**STATE SIGNIFICANT DEVELOPMENT
Section 4.55(1A) Modification Applications**

AUSTRALIAN TECHNOLOGY PARK, EVELEIGH

SSD 7317 MOD 6

Environmental Assessment Report
Section 4.55(1A) of the *Environmental Planning
and Assessment Act 1979*

Figure 2: Part of the northern elevation of Building 2, showing the proposed new signage zone (in Green) and the signage zone to be increased (in Blue) (Base source: Applicant's modification request)

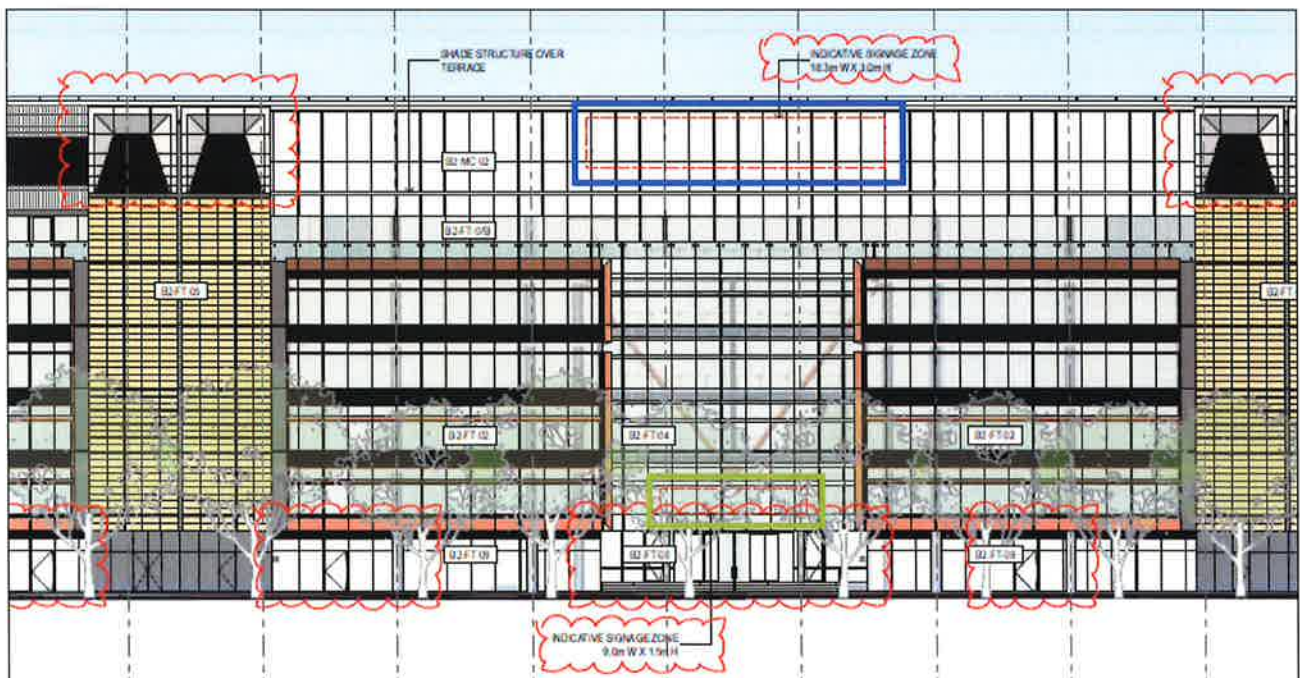
- refinement of façade materials at Lower Ground Level and Plant Level
- changes to the approved signage zones on the southern, western and northern elevations and introduction of a new signage zone on the northern elevation (**Figure 2**).

The Department assessed the approved signage zones against SEPP 64 in its original assessment (SSD 7317), and was satisfied the location of the building identification signs were compatible with the desired amenity and visual character of the area. The proposed changes to the approved signage zones are appropriate, as they involve a minor relocation and mostly reduce the size of the zones. The enlarged signage zone is similarly acceptable as it will not dominate the scale of the building.

The Department therefore supports the proposed changes to the signage zones and addition of one signage zone.

Figure 3: Comparison of approved (left) and proposed (right) north elevation plans showing the signage zone to be relocated and enlarged in green and new signage zone in blue (Source: FJMT)

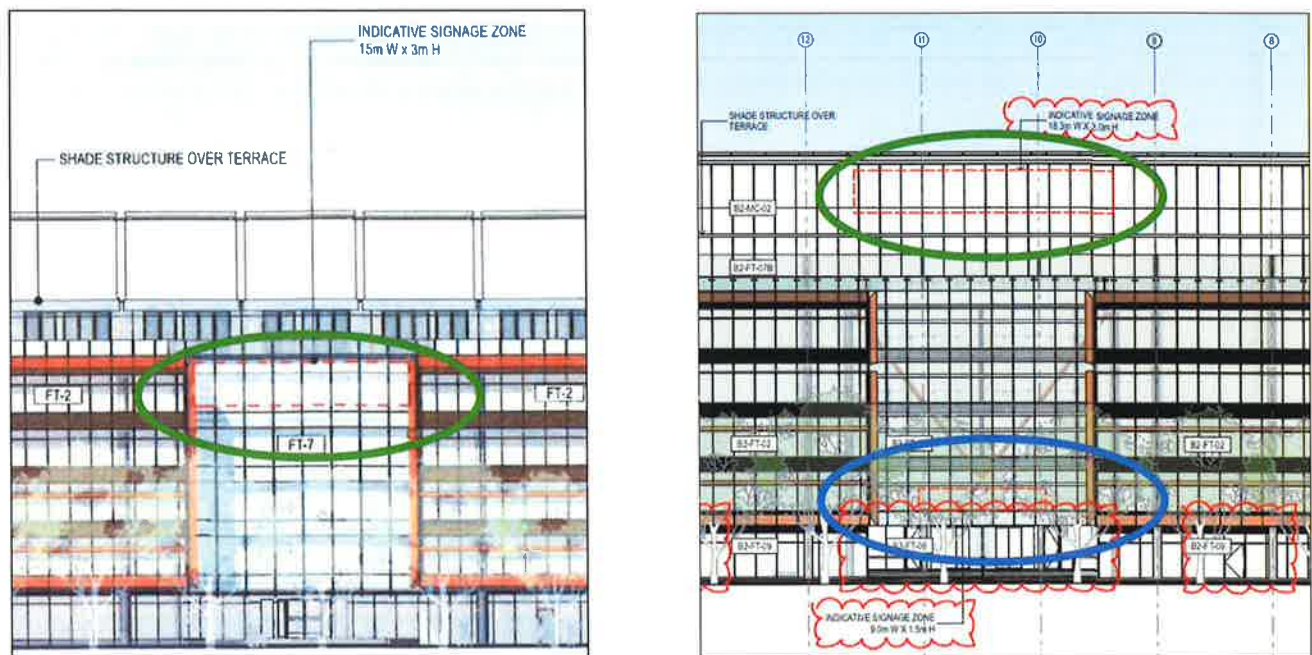
- relocate and reduce (by 8 m²) a signage zone on the southern elevation
- relocate and increase (by 9.9 m²) a signage zone on the northern elevation (Plant Level)
- introduce a new signage zone (13.5 m²) above main entrance on the northern elevation (at Upper Ground Floor level) (**Figure 3**)
- relocate and reconfigure two signage zones on the western elevation

The Department has considered the proposed new signage zone in accordance with Schedule 1 of SEPP 64 (**Appendix B**). The Department is satisfied the proposed changes are compatible with the desired amenity and visual character of the area, and consistent with SEPP 64. The Department also considers that the additional sign will not result in clutter, given the size and position of the new zone above the entrance door. The Department also notes that the original consent (SSD 7317) includes a condition requiring the final signage design, content and illumination within the approved signage zones be approved by the Secretary.

Figure 5: Example showing the reduction in the atria (Level 01), compared to the approved plans above (Source: FJMT)

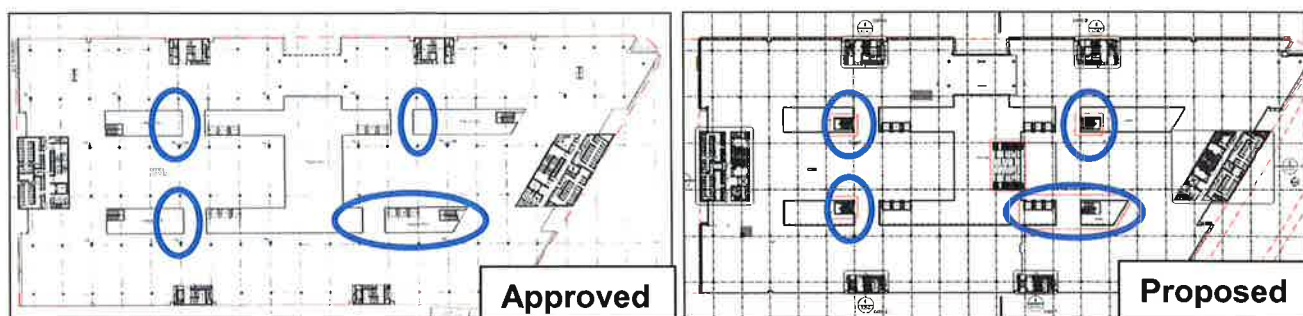
- reconfiguration of the service rooms on Lower Ground Floor level
- inclusion of a drink fountain adjacent to the end of trip facilities and reconfiguration of the entrance into the bicycle storage area on Lower Ground Floor level
- subdivision and reconfiguration of retail tenancies on Lower Ground Floor and Upper Ground Floor levels
- relocation and re-orientation of internal stairs and lift banks and new feature stair (**Figure 4**)
- reduction in the size of the atria on Levels 1 to 5 (**Figure 5**)
- provision of an additional revolving door on the northern elevation
- extension of an awning over the Lower Ground Floor building entrance fronting Village Square
- reconfiguration of the eastern and western amenities layout on Upper Ground Floor level.

The Department supports the proposed changes, as they are minor in nature and unlikely to result in adverse impacts on the surrounding area. This is because Building 2 is located centrally within the ATP and the changes are mostly internal design refinements, that do not adversely change the scale and appearance of the building.

In response to a request for more information from the Department, the Applicant advises the changes will not increase the overall GFA in Building 2, as there have been efficiencies in floor area during the design development (as shown in **Table 4**). The Department supports the minor refinement to the atria, and associated implications to commercial floor area.

While the Applicant has requested that the consent not be modified to reflect the overall decrease in GFA, the Department considers it appropriate and reasonable that the consent be modified to accurately reflect the GFA in Building 2 and align the GFA with the modified approved plans.
